AGENDA

Architectural Review Board

November 14, 2018

2100 Madison Avenue

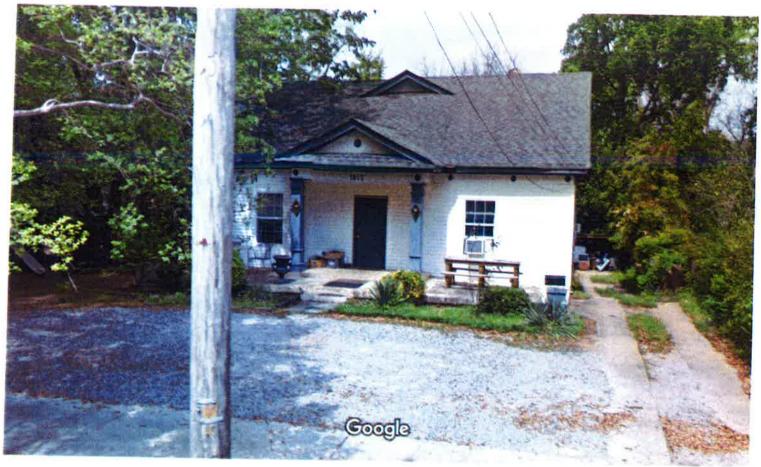
At the October 23, 2018 meeting, the Board delayed the column proposal to give the petitioner time to come up with a more suitable replacement. The Board recommended looking at other historic full height columns in the neighborhood in either a round or tapered square configuration. A full height column traditionally had a taper or trim, and the square columns often had a capital that tied the columns groupings together.

- The column groupings (3 at corners and 2 at internal points) is a typical Montgomery Craftsman configuration.
- At the time the agenda was prepared, no additional documentation had been submitted. Staff did identify two houses on Madison with square columns, which were shared with the petitioner. See photos.

3179 Norman Bridge Road

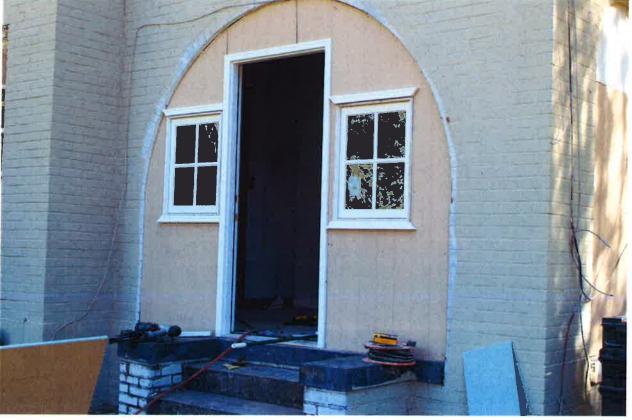
Mr. Taylor appeared at the October 23, 2108 ARB for an advisory review of the work. After much discussion, the remedy agreed upon by the ARB and the owner was to remove the windows entirely and introduce matching sheathing (vertical groove paneling) around the door. Because the item was not advertised for the October meeting, the item had to be placed on the November agenda for an approval to be granted.

•	This item is a confirmation of the discussion and solution to the proposal as it had been constructed.
	COMMENTS
	ACTION

106 South Capitol Parkway

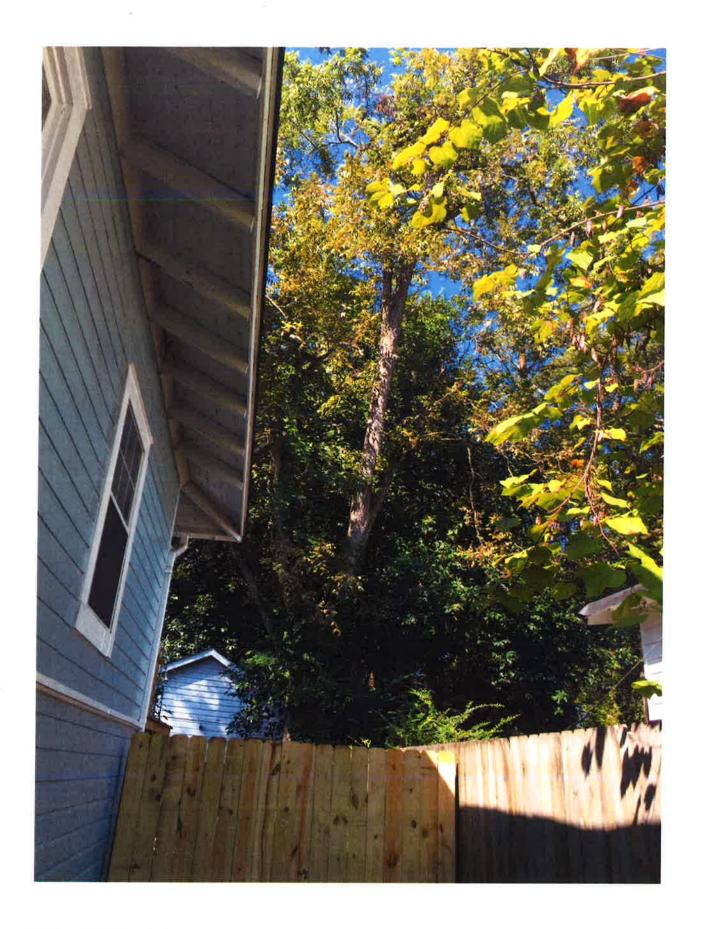
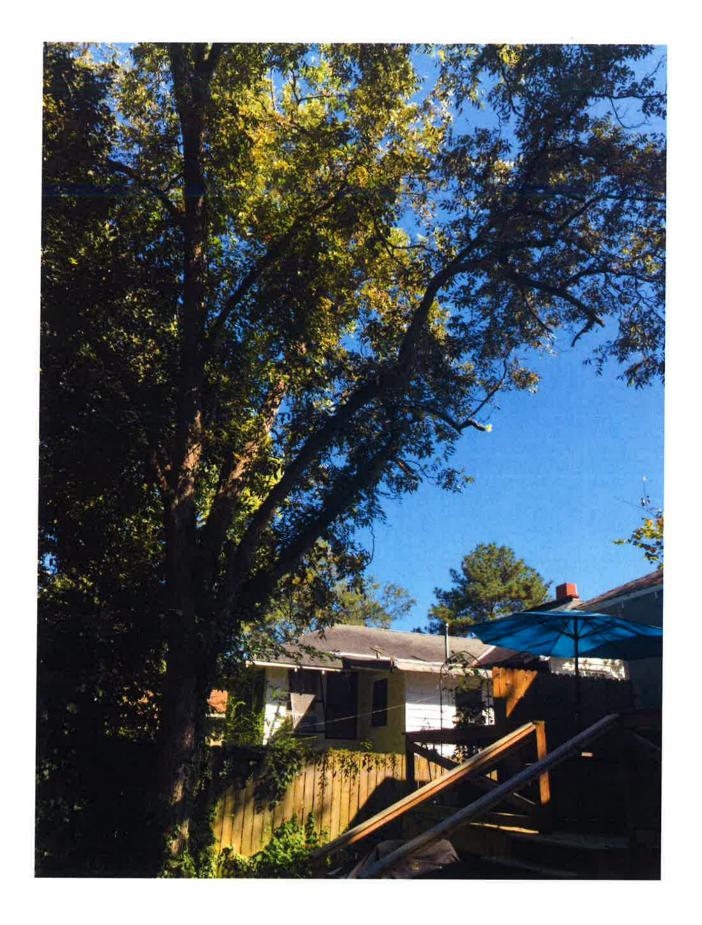
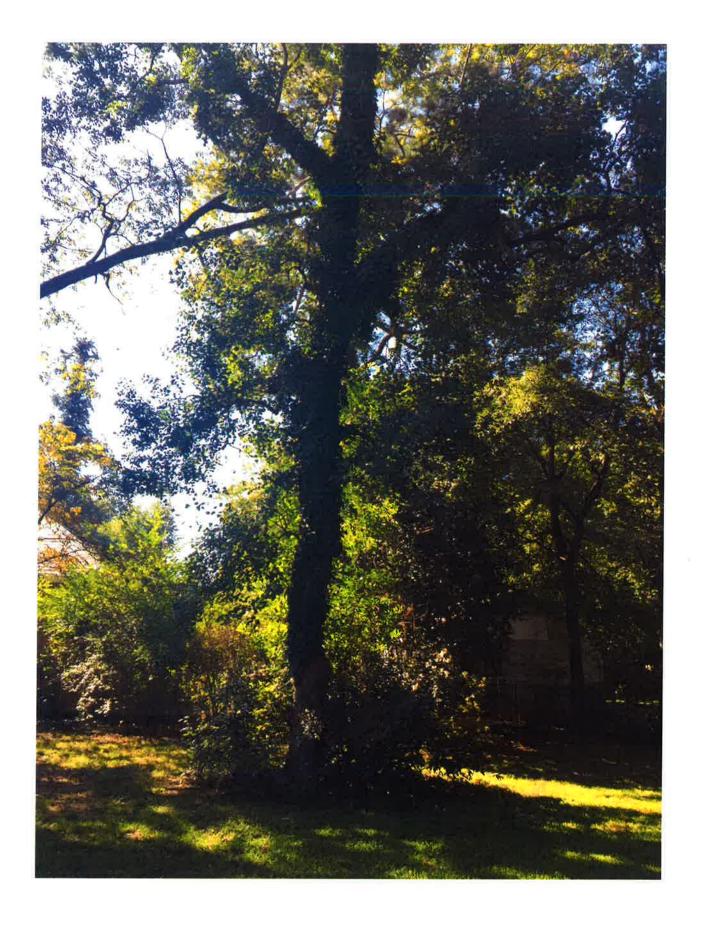
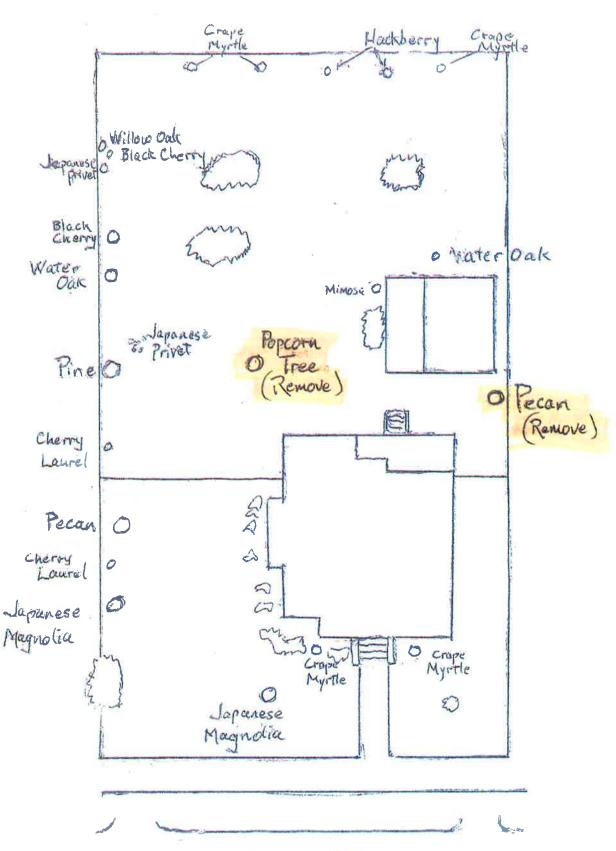
REMARKS: The petitioner is requesting permission to remove a popcorn tree (Chinese tallow) and pecan tree from the rear yard and replace them with two tulip poplars (3" caliper) in the City ROW (street trees) to help re-establish a tree line on the street. The popcorn tree is an invasive species, and the pecan tree does what pecans do, shed limbs continuously. Replacement time will be in November/December of 2018.

•	No objection.
	COMMENTS
	ACTION

707 Thorn Place

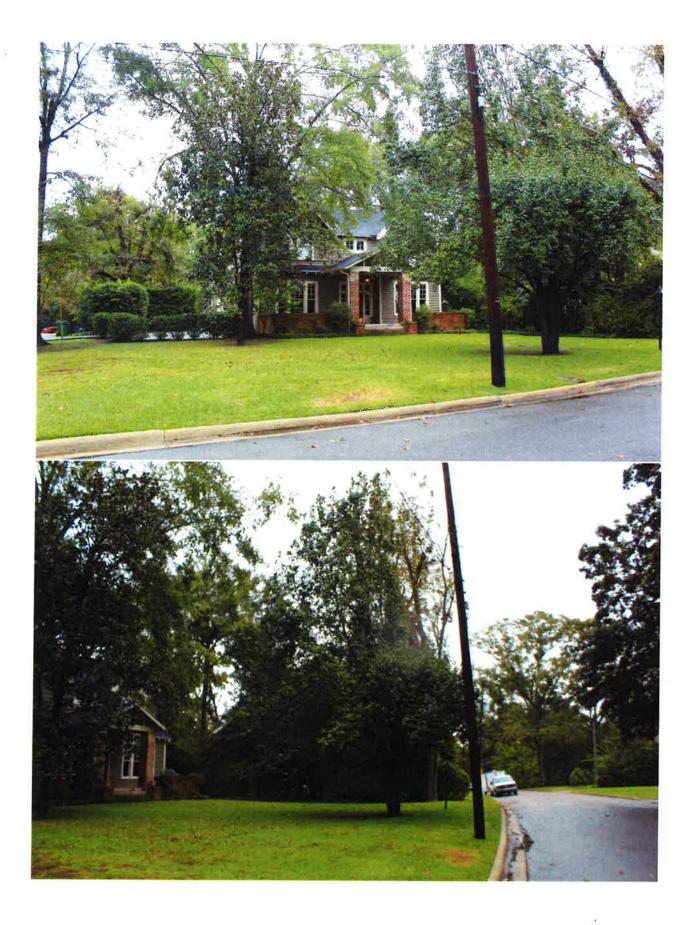
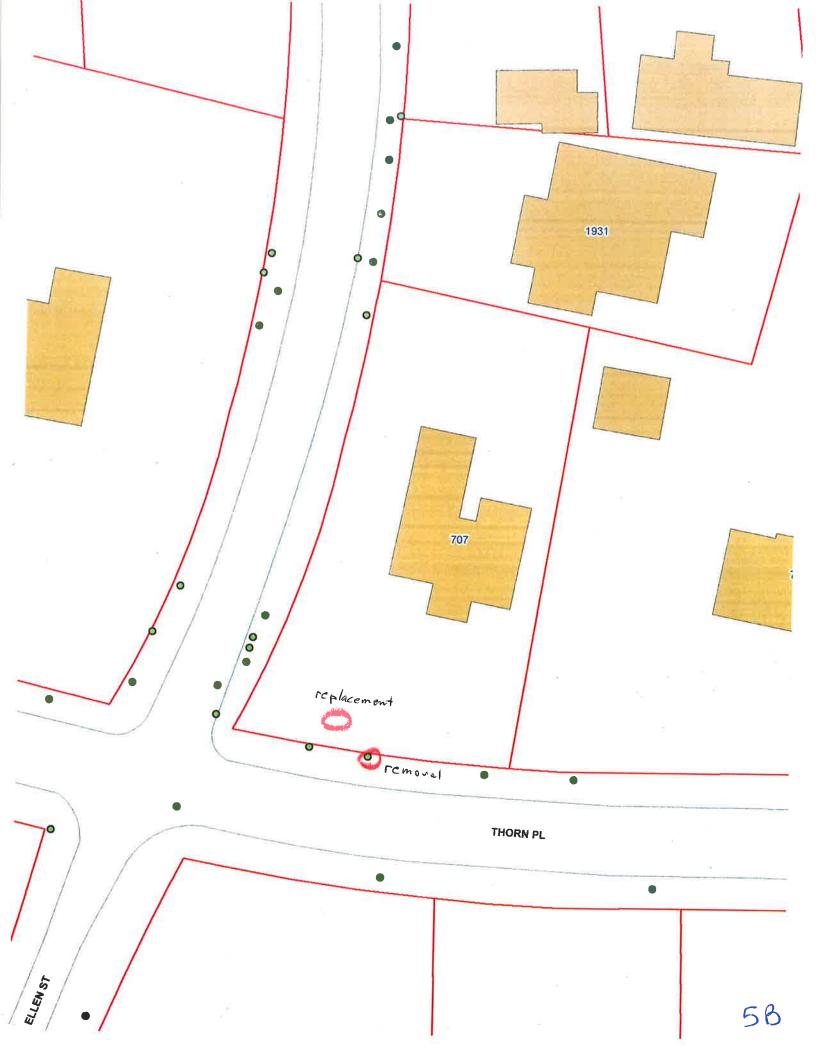
REMARKS: The petitioner is requesting permission to remove an 8" diameter Bradford pear (invasive) from the ROW and replace it with a 2.5" caliper Overcup Oak in FY 2019 (Nov 2019-March 2020 planting season).

740 Felder Avenue

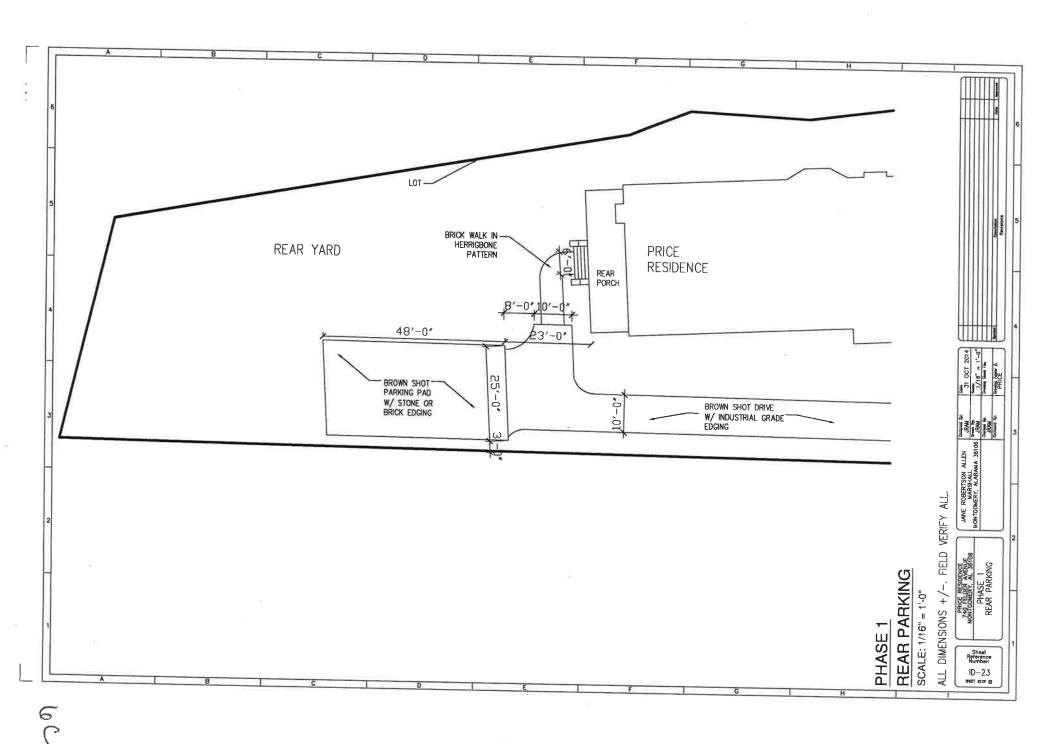
REMARKS: The petitioner is requesting permission to create a brown shot 25'x48'parking area edged with brick or stone at the end of the previously approved driveway and a brick or stone walkway from the parking area to the rear of the house as illustrated.

• Rear yard parking is always preferable to front yard parking. No objection.

554 East Fairview Avenue

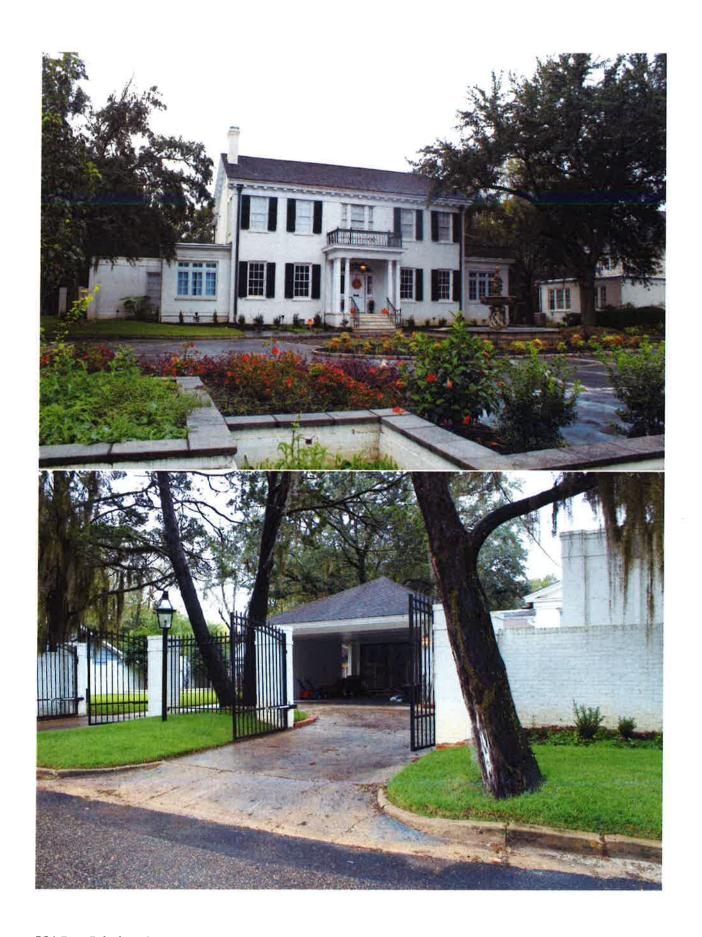
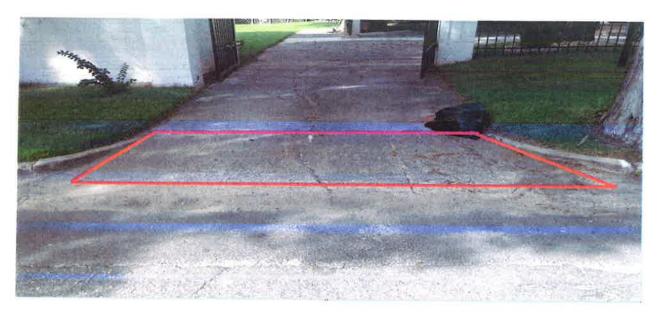
REMARKS: The petitioner is requesting permission to install rows of ballast stone in the driveway apron in a 6' band where illustrated. The petitioner is also requesting permission to install a single steel garage door on the existing car port. Door will be paneled with windows in the top row.

The Board has approved a variety of garage door materials.

3112 Lexington Road

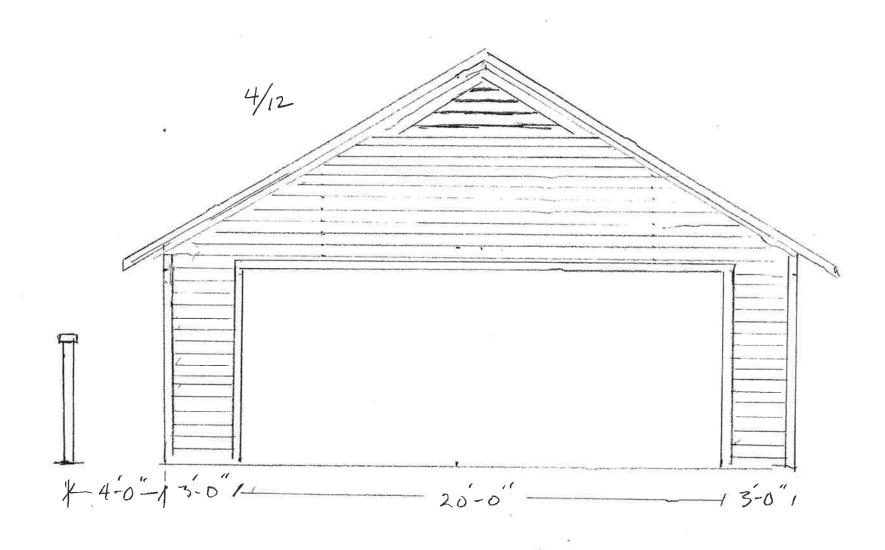
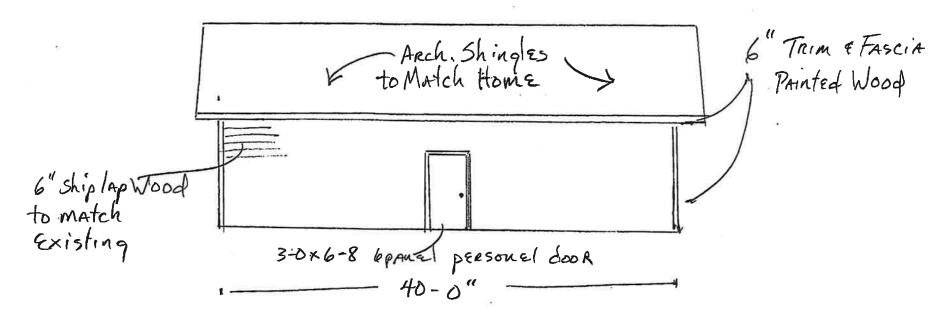
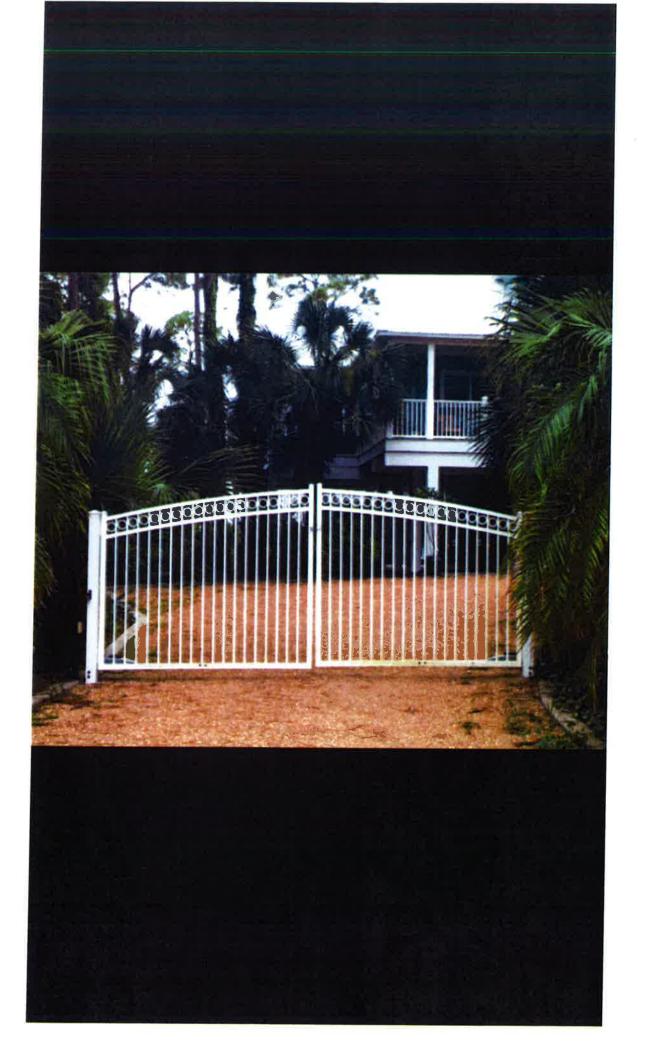
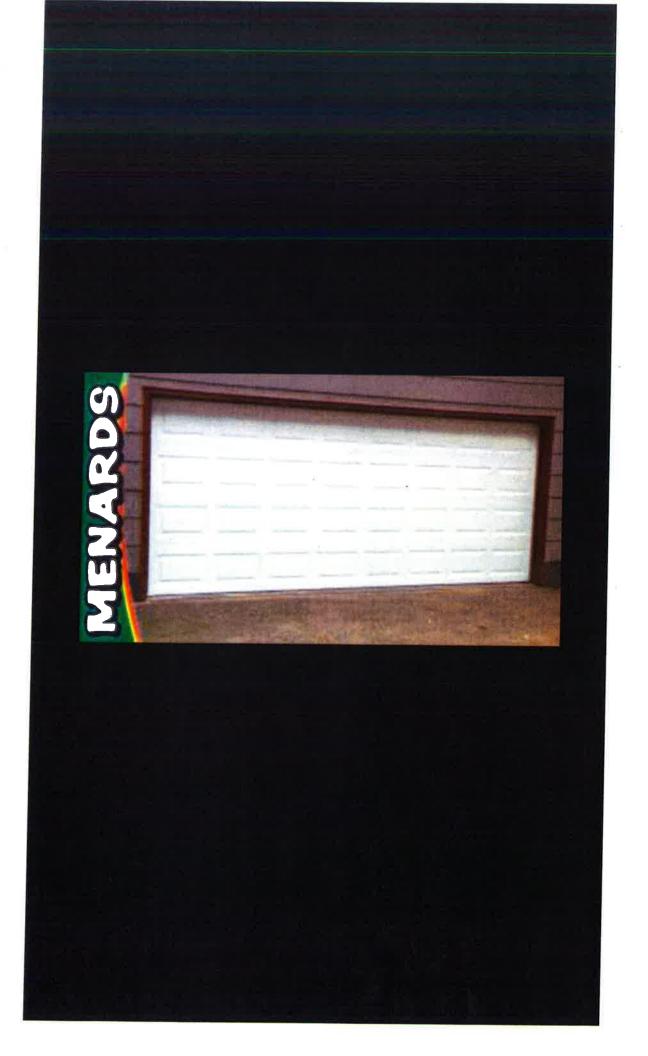
REMARKS: The petitioner is requesting permission to demolish an existing 20'x24' garage and concrete approach to construct a new 26'x40' garage with wider concrete apron. Garage to be built in a style similar to existing: 6" shiplap siding, 6" trim and fascia painted to match house; architectural shingles to match house on a 4\12 roof. Garage door will be solid panel steel overhead door, and a 3' walkthrough door is proposed on the north elevation. The existing fence will be removed where illustrated, and a driveway gate is proposed in the style and location illustrated. The garage will be placed 5' off the property line instead of 4' as shown on site plan to avoid the need for a setback variance. A coverage variance will be required. The existing 6'x8' storage building will be moved over with at least 10' of separation between the two structures.

The Board has approved steel doors for outbuildings.
